P/21/0225 - ALDI MERTHYR TYDFIL EXTENSION - RESPONSE TO NRW COMMENTS

Further to comments from Natural Resources Wales regarding the above proposal, contained within their letter report reference CAS-157378-J9X8, we write to respond as follows.

CAR PARK AND STORE EXTENSION
PLYMOUTH STREET
MERTHYR TYDFIL

PROPOSED LEVELS
FLOOD ANALYSIS

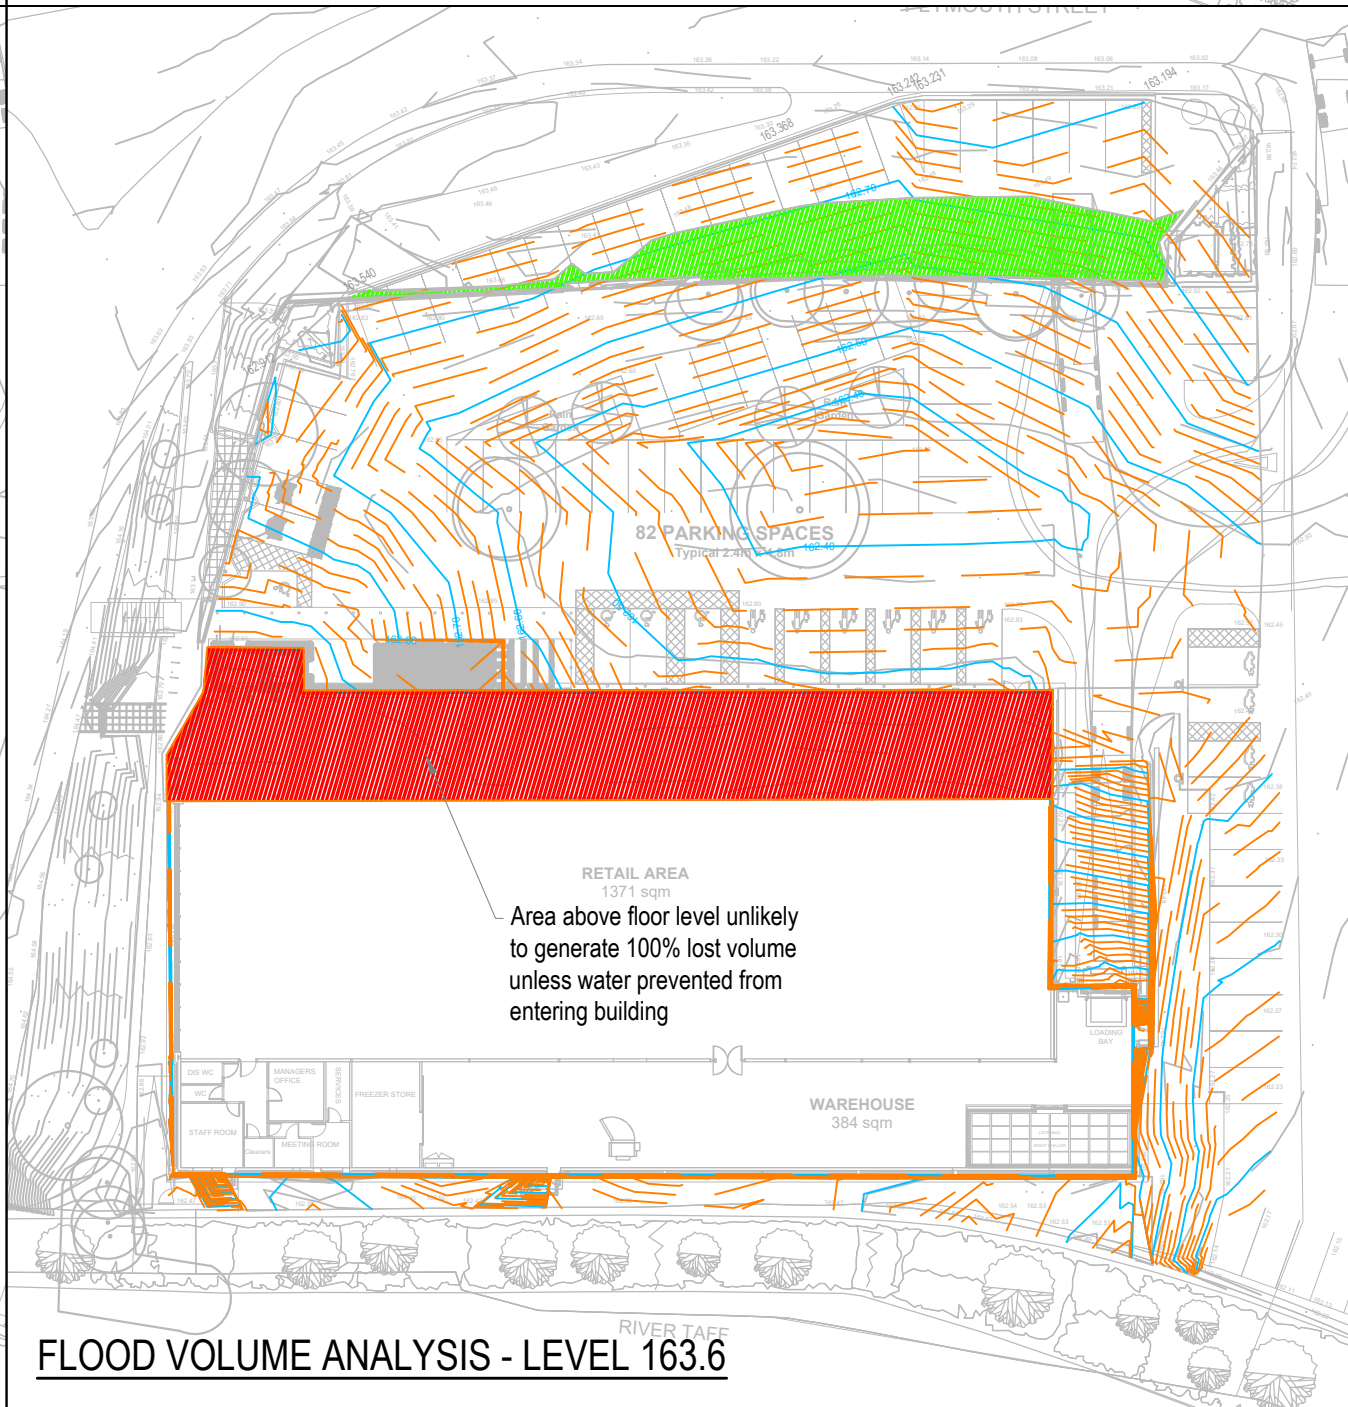
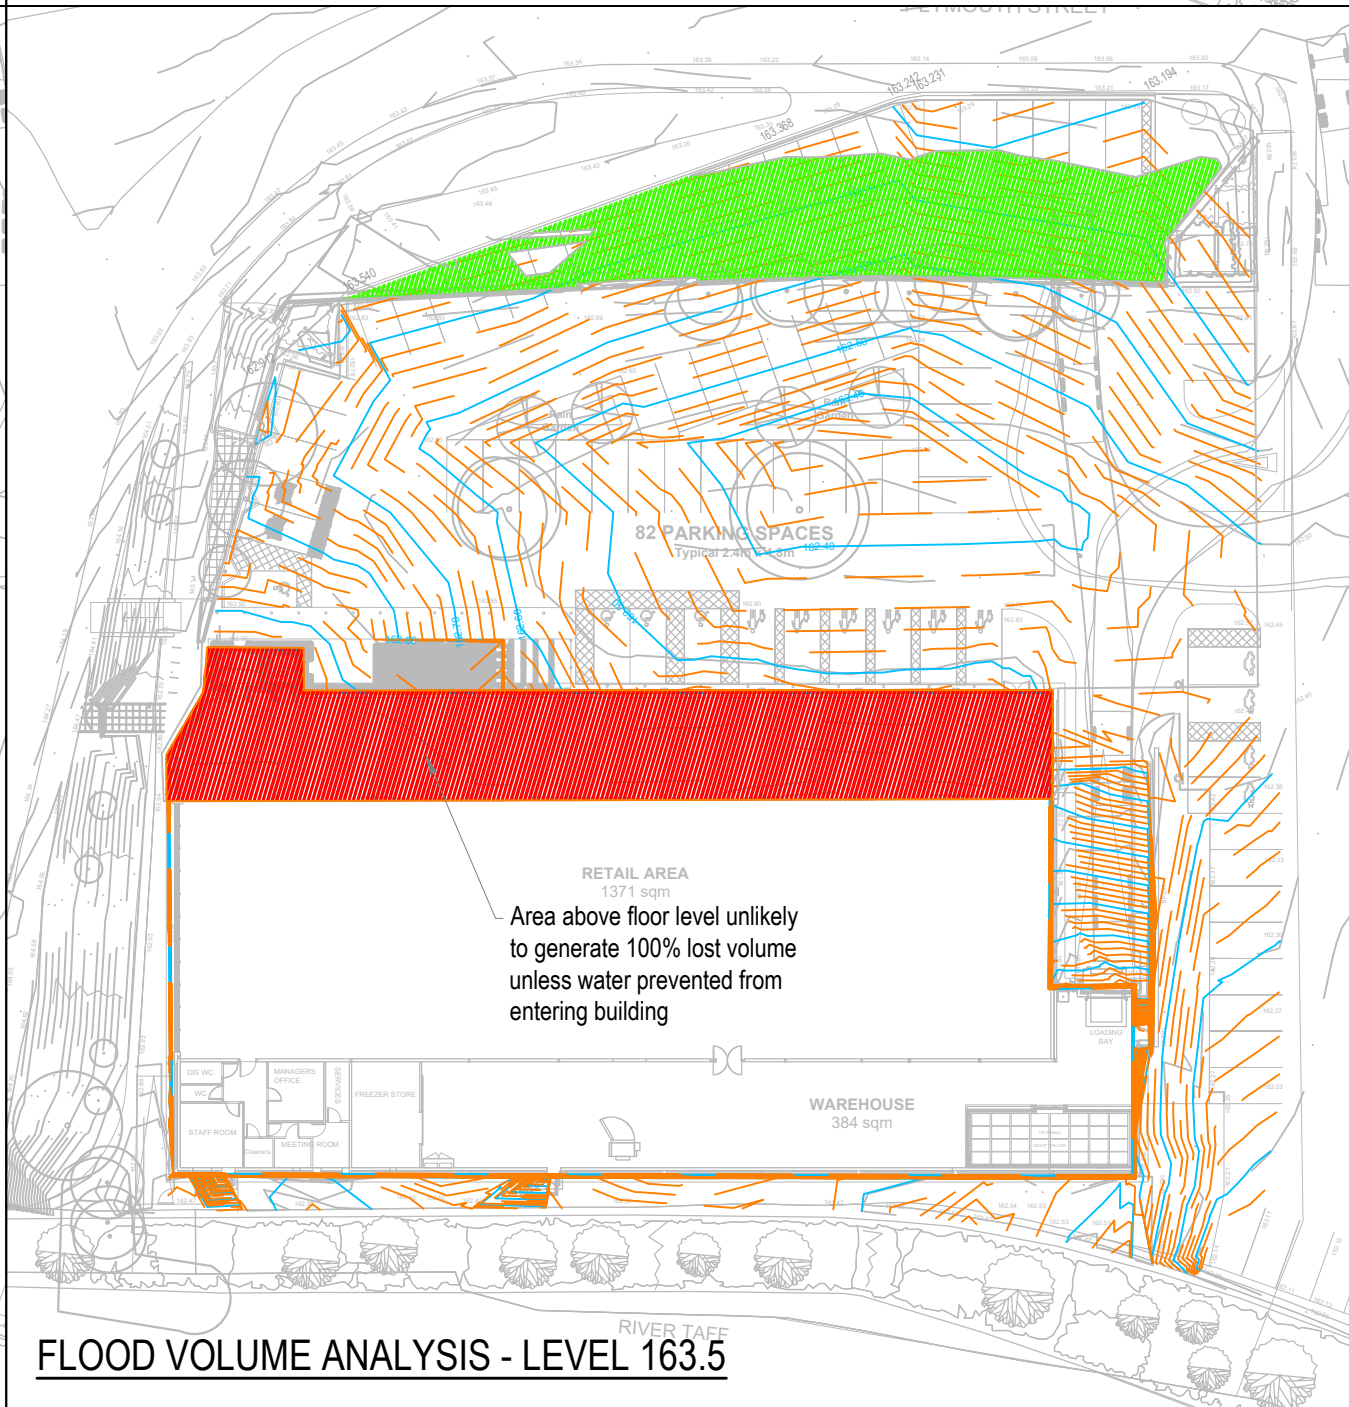
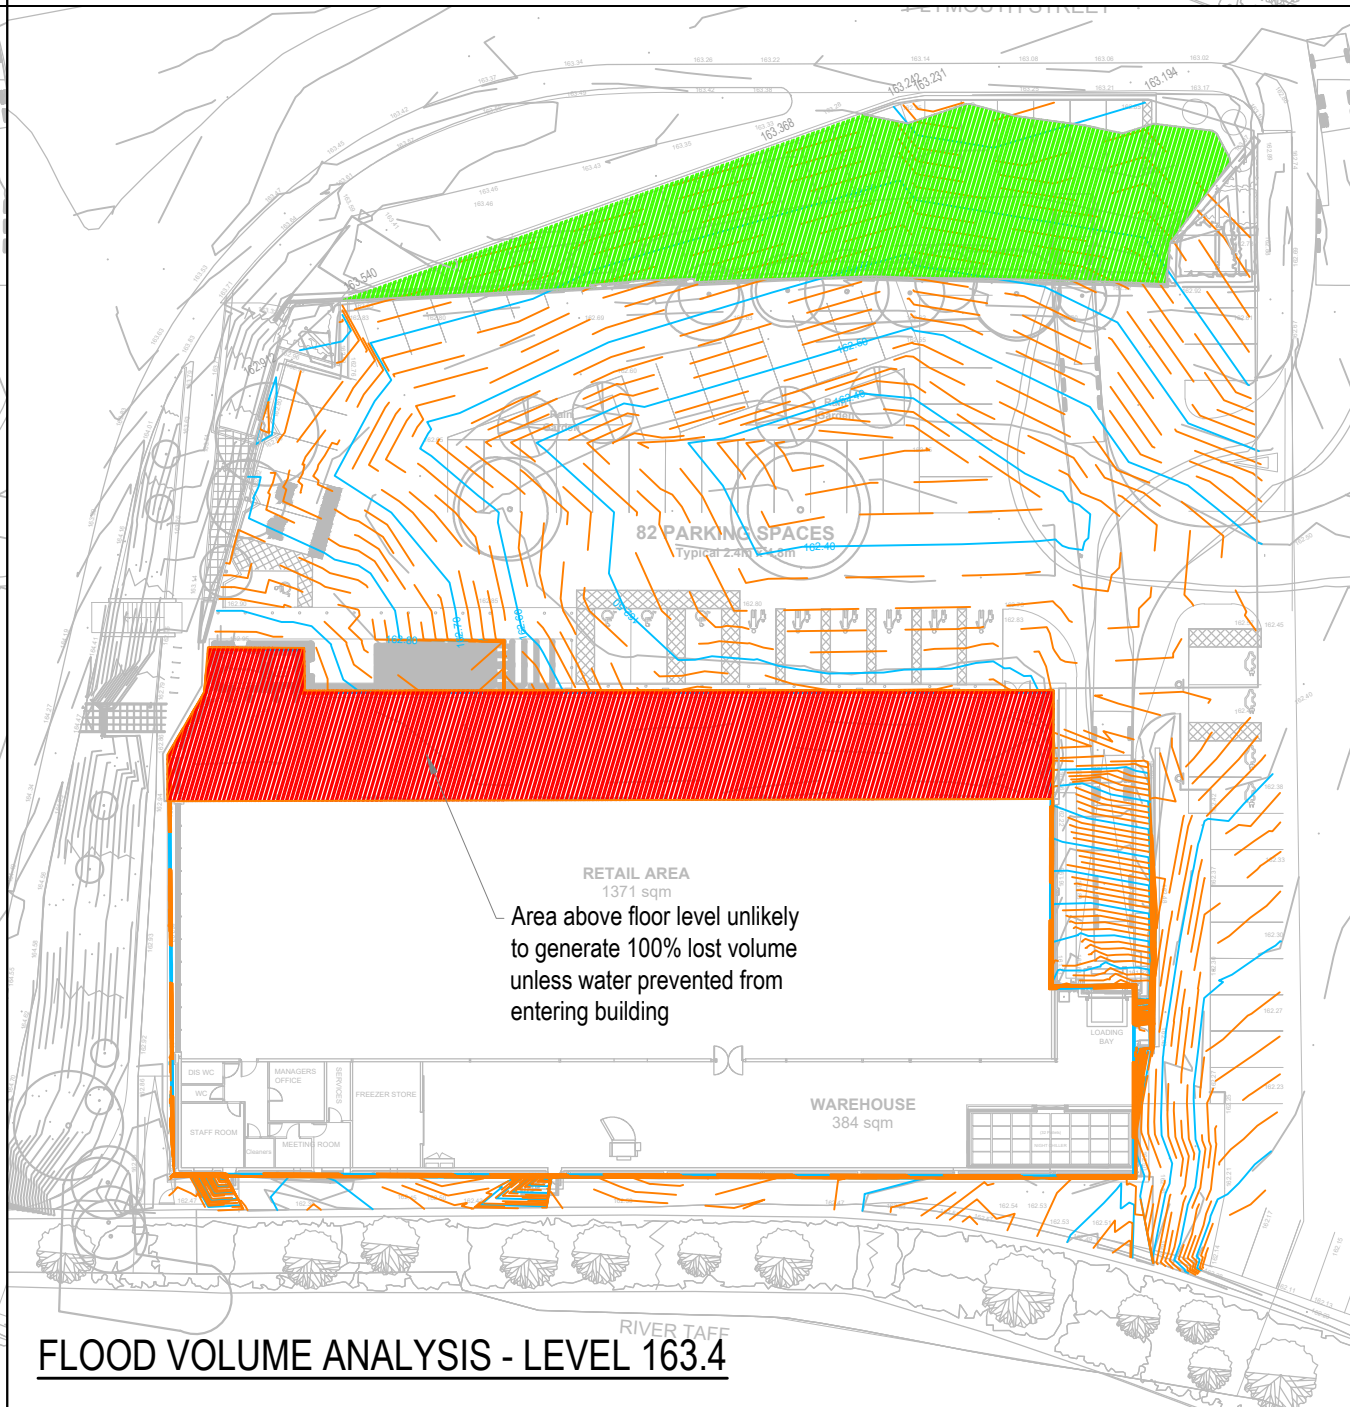
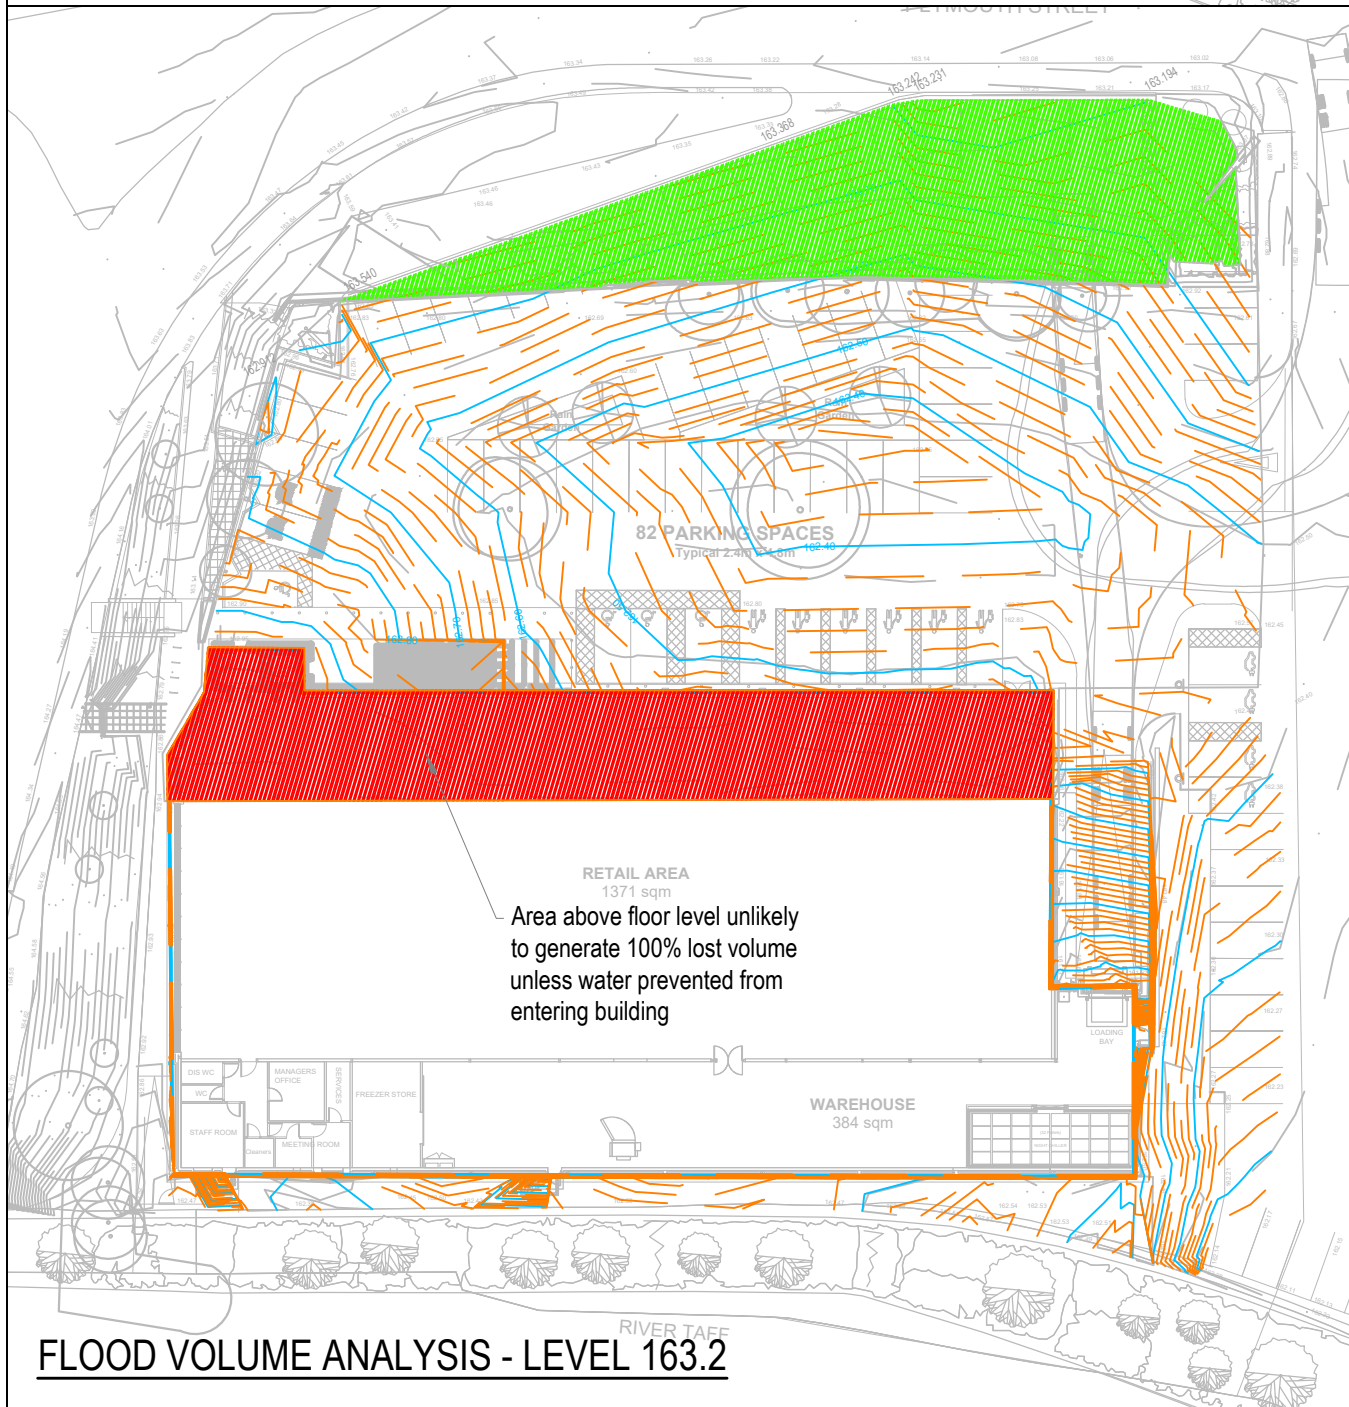
Beyond this, the entire site is likely to be inundated during the 1 in 1000-year event, since it is within the area shown as being affected on the FRAW map. It is therefore important to review flood volumes during such an event. A level-for-level analysis has therefore been carried out, as shown in sketch 0001 revision C enclosed.

0.1 metre depth "slice"	Flood plain loss (m²)	Flood plain gain (m²)	Difference (m²)
162.20	Approximate 1 in 100-year (1% AEP) flood level		
162.3 - 162.4	53.7	113.7	+60.0
162.4 - 162.5	62.7	130.5	+67.8
162.5 - 162.6	156.4	157.2	+0.8
162.6 - 162.7	284.4	294.6	+10.2
162.7 - 162.8	392.7	480.7	+88.0
162.8 - 162.9	431.8	515.3	+83.5
162.9 - 163.0	438.3	488.6	+50.3
162.95	Building floor level		
163.0 - 163.1	438.3*	478.0	+39.7*
163.1 - 163.2	438.3*	465.9	+27.6*
163.2 - 163.3	438.3*	414.1	-24.2*
163.3 - 163.4	438.3*	326.9	-111.4*
163.4 - 163.5	438.3*	166.6	-271.7*
163.5 - 163.6	438.3*	49.6	-388.7*
163.70	Approximate 1 in 1000-year (0.1% AEP) flood level		
*based on no water entry into building

It is therefore possible to increase flood volume storage within the site for all flood levels up to the building floor level, and to a depth of 250mm above the floor level.

Beyond this level, without any water entering the building, the proposed development would displace flood volume – this is because there is a decreasing area of the existing site area that can be lowered, to offset the additional building area.

It is therefore proposed not to exclude water from the building for flood events that may exceed the floor level – this is particularly important as since the proposed development is for an extension to an existing building, it will not be practicable to develop a water exclusion strategy for higher level flood events, since the existing structure will not be designed to withstand the higher head of water.

As such floodwater will enter the building and not be displaced by the proposed extension. The anticipated depth of internal flooding during the 1 in 1000-year event is approximately 750mm. The building should therefore be evacuated in the event of a flood warning being issued – as mentioned in the original FCS the store does lie within a Flood Warning Area. A flood warning and evacuation plan should be developed, if one does not currently exist for the store.
